STRUCTURAL CALCULATION COVER SHEET

Calculation No:3442.053.SCAL.005,
Calculation Title: CCF VFD FREE STANDING FLOOR MOUNTED SUPPORT
Project ID # 100256
Project Title: CCN CHILLED WATER SYSTEM OPTIMIZATION MASTER PLAN

Rev.	Reason for Revision
REV A	FIRST SUBMITTAL OF CALCULATIONS
Rev. 0	All pages of this calculation 3442.053.SCAL.005 Rev. A are considered Rev. 0, approved and released based upon no technical changes to the calculation during /after formal review.

VFD SUPPORT
NTS

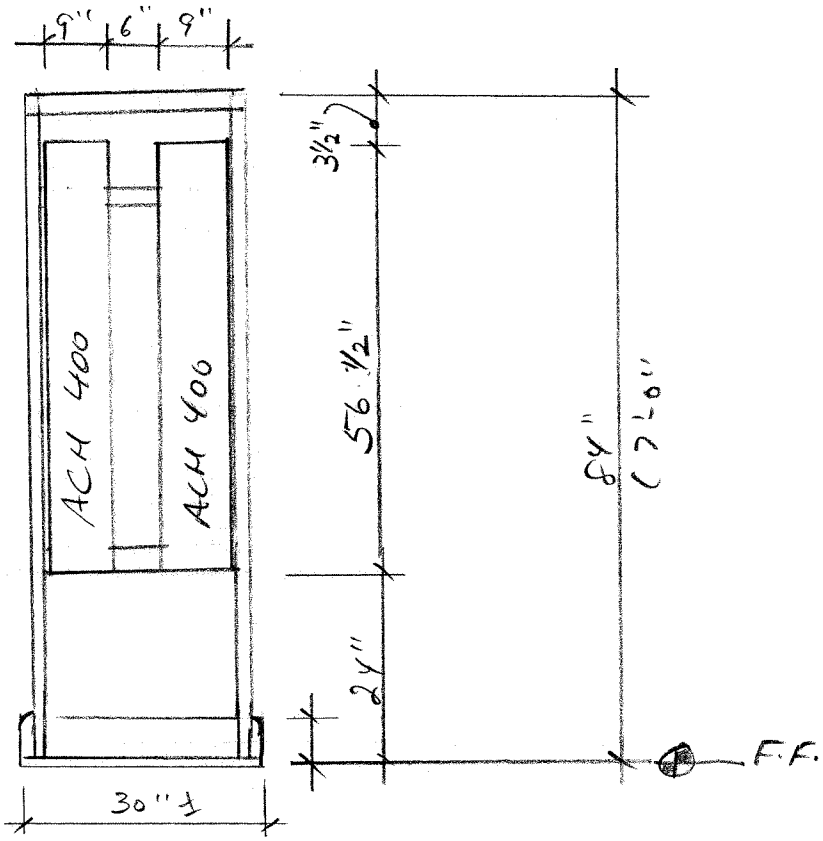
NOTE: 10/1/01 DAVID WALKER changed VFD to larger, heavier units. Details reused ⇒ ⊥L and P5000 used

CCN CHILLED WATER SYSTEM
OPTIMIZATION MASTER PLAN
MECH: SECTIONS

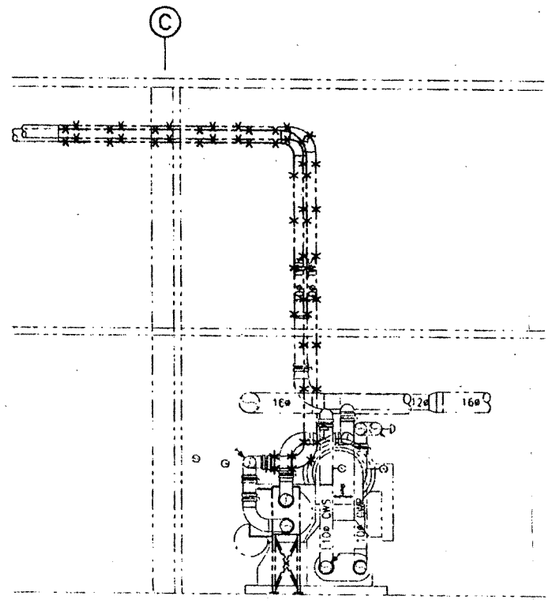
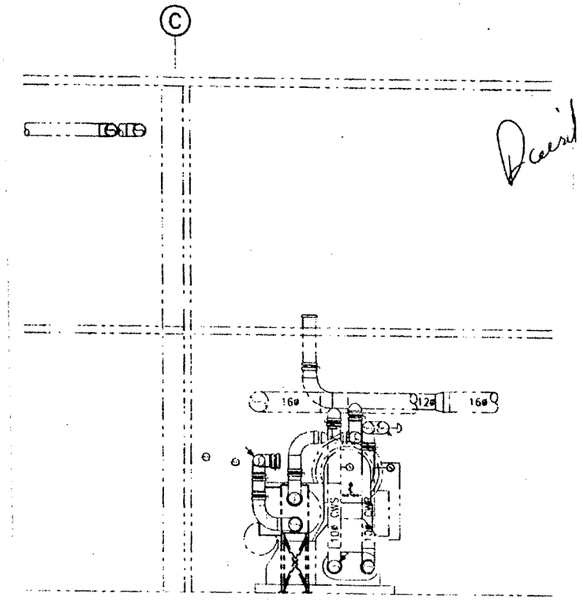
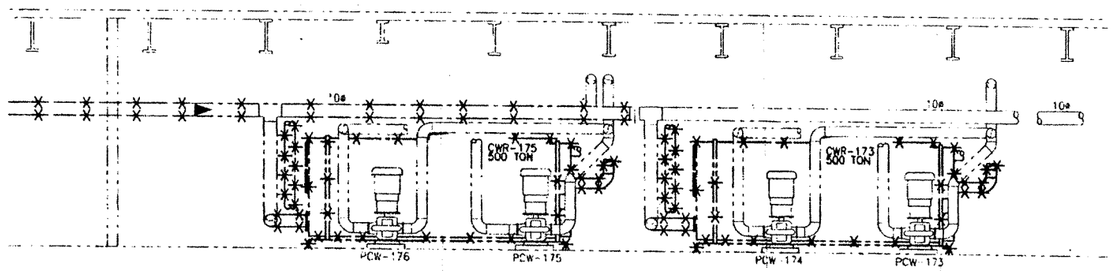
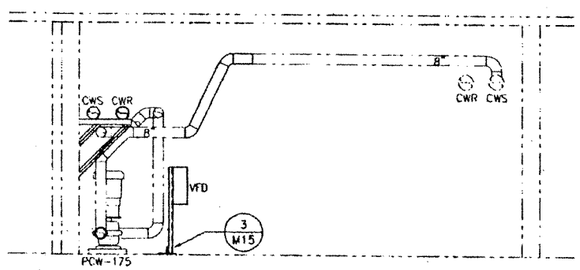
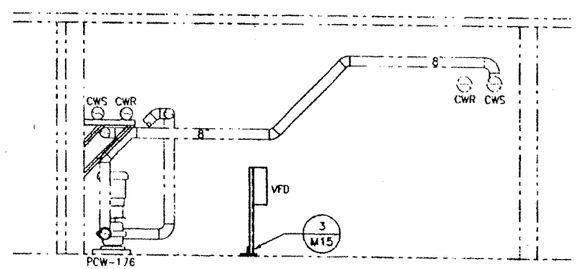
ADD NOTE
TO Details D, E
Floor stand supports
for piping not shown
for clarity. See
M-10 for locations.
ok Show them?
(comment from 10/9 review)

PIPE HANGER SUPPORT

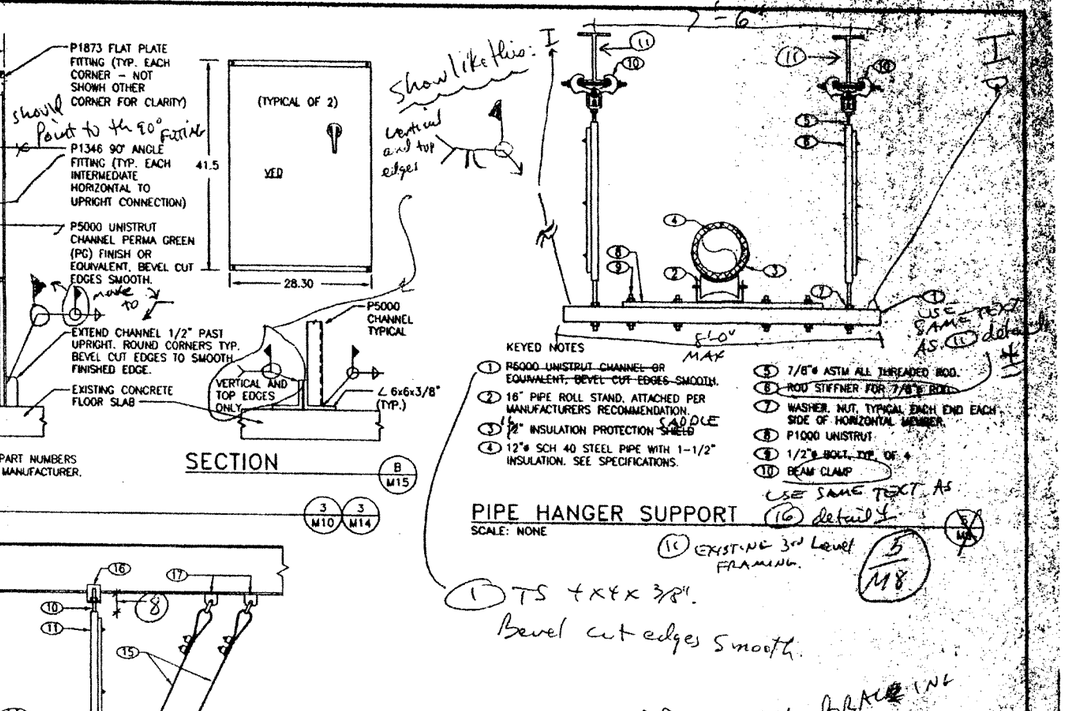
ADD SWAY BRACING to DETAIL 5 USE (4/MF) components & call outs w/ correct keynote #'s.
